# **525.** FEDERAL AVENUE EAST.

PROJECT NUMBER: 3024903 | RECOMMENDATION PACKET | AUGUST 23RD 2017.

### NARRATIVE RESPONSE.

#### FACADE LENGTH.

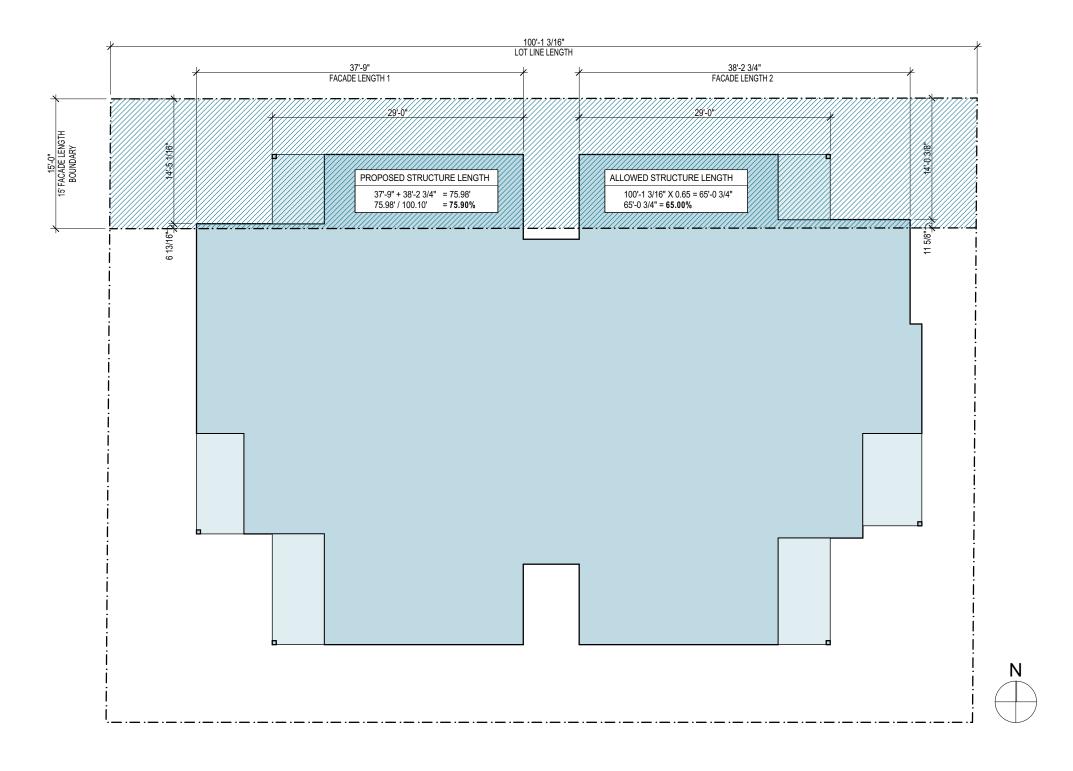
TO ALLOW THE BUILDING TO EXCEED THE MAXIMUM FACADE LENGTH ALLOWED ALONG THE NORTHERN PROPERTY LINE.

THE MAXIMUM COMBINED LENGTH OF ALL PORTIONS OF FACADES WITHIN 15 FEET OF A LOT LINE THAT IS NEITHER A REAR LOT LINE NOR A STREET OR ALLEY LOT LINE SHALL NOT EXCEED 65 PERCENT OF THE LENGTH OF THAT LOT LINE, EXCEPT AS SPECIFIED IN SUBSECTION 23.45.527.B.2

INCREASE MAXIMUM FACADE LENGTH WITHIN 15 FEET OF THE NORTH PROPERTY LINE TO 76% OF THE LENGTH OF THAT LOT LINE

OUR BUILDING IS PUSHED TO THE NORTH, ALLOWING US TO PROVIDE AN ADA ACCESSIBLE RAMP ALONG THE SOUTH FACADE TO ACCESS OUR COMMON AMENITY AREA AT THE WEST END OF THE SITE. WE ALSO ARE PROVIDING A LANDSCAPE BUFFER AND AN EXISTING TREE BETWEEN THE WALKWAY AND NEIGHBORING SITE. FURTHERMORE OR DEPARTURE IS ONLY NECESSARY TO ACCOMODATE THE LAST 6 3/4" INSIDE OF THE 15' OFFSET FROM THE PROPERTY LINE.

# PROPOSED DEPARTURES. REAR SETBACK.

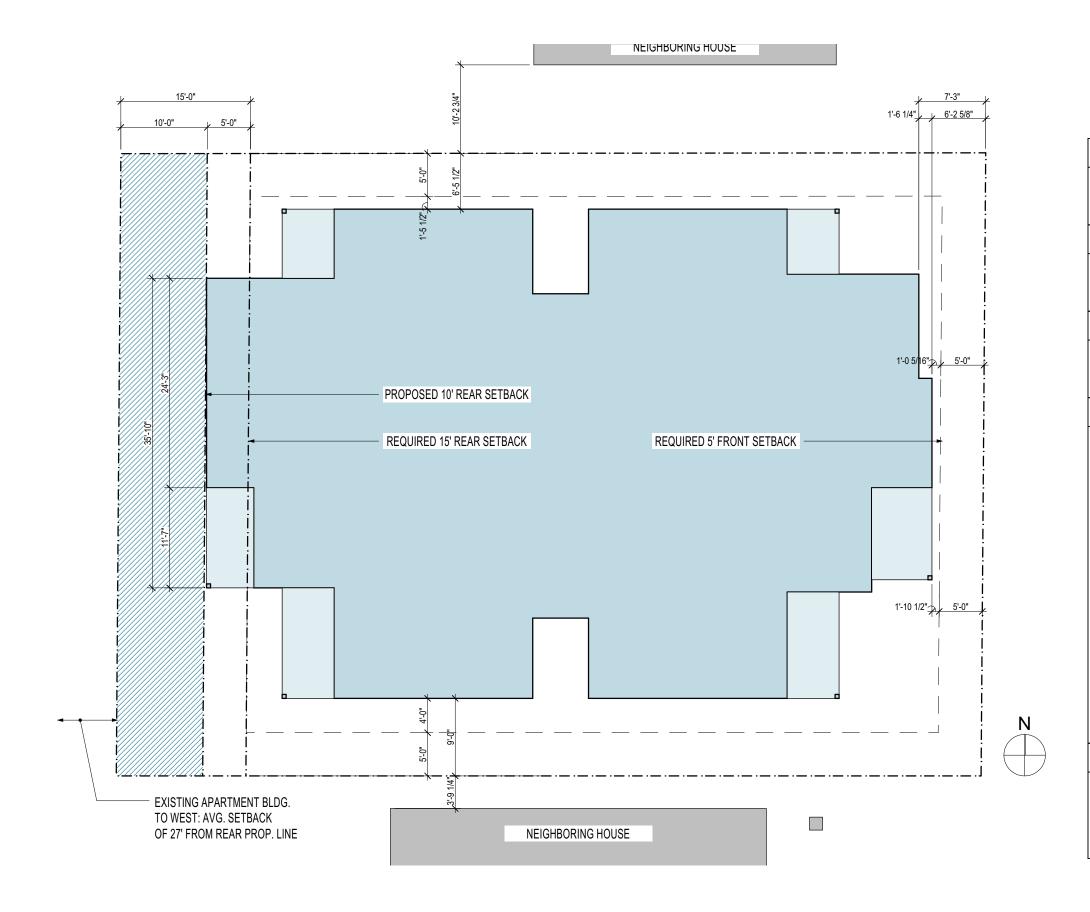
TO REDUCE THE REAR YARD SETBACK.

REAR SETBACK: 15' MINIMUM IF NO ALLEY

REDUCTION TO THE REAR SETBACK TO 10'-0"

WE ARE PROPOSING TO SET THIS BUILDING BACK FROM THE STREET MORE THAN THE MINIMUM REQUIREMENT IN ORDER TO MAINTAIN A BETTER RELATIONSHIP TO THE SURROUNDING BUILDING'S STREET FACADES. ADDITIONALLY, WE PROPOSE LARGER SETBACKS FROM NEIGHBORS BOTH NORTH AND SOUTH IN ORDER TO ENCOURAGE GREATER PRIVACY FOR BOTH OUR BUILDING AND OUR NEIGHBORS. INCREASING THE SIDE SETBACKS ALSO HELPS TO SCALE DOWN OUR BULK AND SCALE ALONG FEDERAL AVE. THE BUILDING BEHIND OUR SITE IS A LARGE-SCALE APARTMENT COMPLEX WITH AN AVERAGE SETBACK OF 27' FROM OUR REAR LOT LINE. REDUCTION OF OUR REAR SETBACK ACCOMODATES A MORE APPROPRIATE FACADE DISTANCE ALONG FEDERAL AVE, PROVIDES MORE PRIVACY TO NEIGHBORS EAST AND SOUTH, AND DOES NOT COMPROMISE THE PRIVACY OF THE APARTEMENTS TO THE WEST.
